Product Change Notification: PCN-24-228019

ECK50B and ECK100B series DC contactor

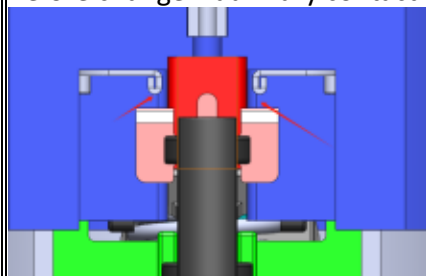
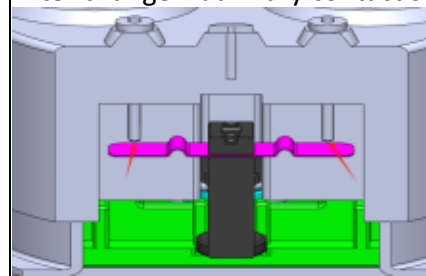
Product improvement, optimize auxiliary contact structure of ECK50B and ECK100B series DC contactor. Please be aware of an upcoming feature change to the listed part numbers. Before: mechanical endurance of auxiliary contact is 250k cycles; After: mechanical endurance of auxiliary contact is 300k cycles;

Before change---auxiliary contact structure

After change---auxiliary contact structure
